# Service Bulletin

Outboard No. 2005-07 OEM No. 2005-05

## Mercury 4000 Series Panel Mount Control - Pistol Grip

a - Label on bottom side of housing

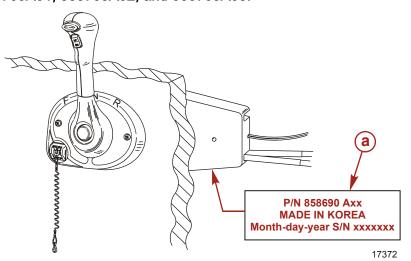
Mercury 4000 Series Panel Mount Remote Controls listed below that:

- 1. Have been installed in boats with the **last four digits** of the Hull Identification Numbers (HIN) between J000 (October, 2000) through F505 (June, 2005) are affected.
- 2. Have remote controls with dates of manufacture that are on the labels located as shown in the figure below between October, 2000 and May, 2005.

Mercury Marine has identified a potential problem with the manufacturing of the 4000 series pistol grip panel mount remote controls. The amount of force required to move the shift handle out of the "NEUTRAL" detent lock position without depressing the release button, in a very small percentage of these controls, was found to be below specification.

Replace the handle and bezel on all controls that fail the test procedure listed above. Record the engine serial number and the boat HIN on the warranty claim form.

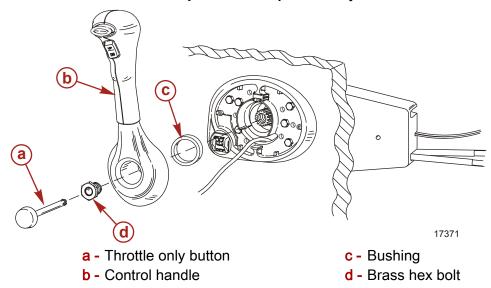
IMPORTANT: The main purpose of this test is to ensure that the neutral detent lock cannot easily be overridden without depressing the neutral release button.

- 1. Place the control handle in the "NEUTRAL" shift position.
- 2. Check the control handle for excessive free play. It should be minimal. If there is excessive free play, proceed to step 4.

- 3. Check the neutral lock by:
  - a. Cycling the control handle through its shifting range ("NEUTRAL" to "FORWARD" to "NEUTRAL" to "REVERSE" and back to "NEUTRAL") several times. Then place the handle in the "NEUTRAL" position.

- b. **ONLY** while seated in the driver's seat, push the control handle forward without depressing the neutral release button using normal pressure for operating the remote control. Do not strike or hit the handle. Handle lock should retain the handle in the "NEUTRAL" position.

- c. Use the same procedure for "REVERSE" direction.
  - d. If the handle lock does not hold the "NEUTRAL" position, replace the handle and bezel as described in the **Parts Required** section of this bulletin and submit a warranty claim under **Replacement**.

- e. If the handle lock functions properly, no further action is required.
- 4. If excessive free play is felt, it indicates that either the bolt that secures the handle to the control may not be fully seated or the bushing between the handle and bezel is missing. Either condition may allow the control handle to shift into gear without depressing the neutral release button while using minimal force. The excessive free play condition must be corrected before proceeding with any testing as described previously.

- a. Remove the throttle only button by:
    - Placing the control handle in the "NEUTRAL" position.
    - Push in the throttle only button.
    - Advance the handle forward to the first detent felt.

- Release the throttle only button and carefully pry it out. This exposes the hex head bolt in the bore of the handle.
  - b. Loosen the bolt approximately 1/4 turn. Then retighten the bolt and torque to specification. This should rectify the free play condition.
